Publication No. 7C8767
19OCT99

MODIFICATION INSTRUCTIONS for the *Kodak X-Omat* 3000 RA PROCESSOR Service Code: 3434 Modification No. 3 and the *Kodak X-Omat* 270 RA PROCESSOR Service Code: 3059 Modification No. 25

Purpose: To improve equipment reliability by installing:
- new and improved QUAD POWER SUPPLY
- FOAM STRIP to direct the heat away from the ELECTRICAL BOX

Figure 1 **QUAD POWER SUPPLY**

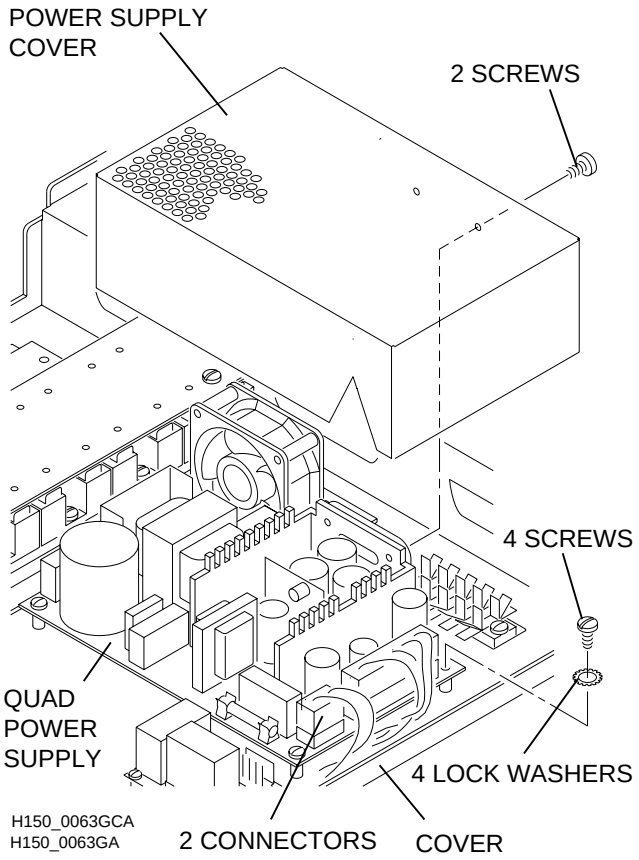
Installing the New QUAD POWER SUPPLY

[8] Remove the existing QUAD POWER SUPPLY.

[9] Install the new QUAD POWER SUPPLY.

Figure 2 **3000 RA PROCESSOR**

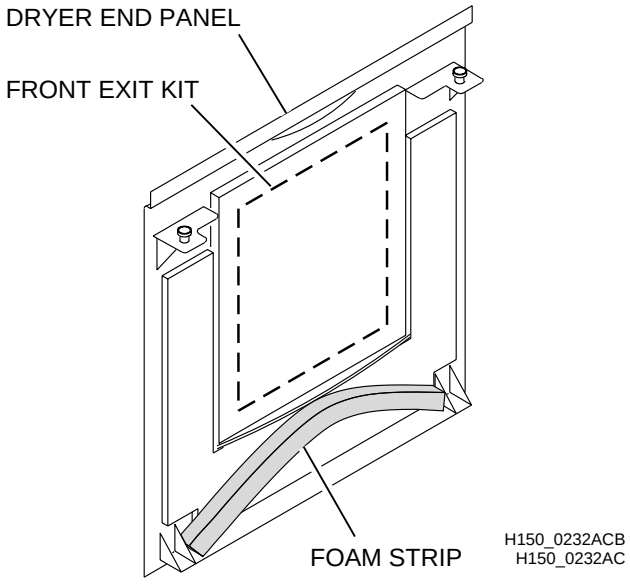
[2] Remove the backing from the new 3.8 x 3.8 x 63.5 cm (1 1/2 x 1 1/2 x 25 in.) FOAM STRIP 3H8283 and adhere it to the inside of the DRYER END PANEL.

Figure 3 **270 RA PROCESSOR**

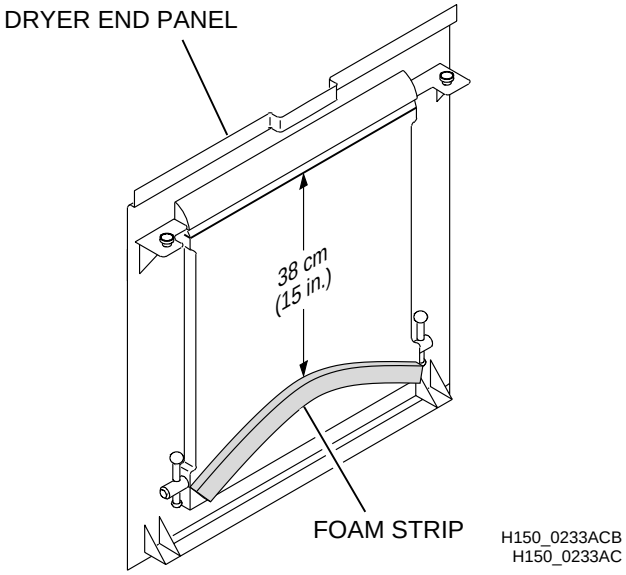
[3] Cut the new 3.8 x 1.9 x 71.1 cm (1 1/2 x 3/4 x 28 in.) FOAM STRIP 3H9052 to a length of 52 cm (20 1/2 in.) and discard the short piece of FOAM.

[4] Remove the backing from the FOAM STRIP and adhere it to the inside of the DRYER END PANEL.
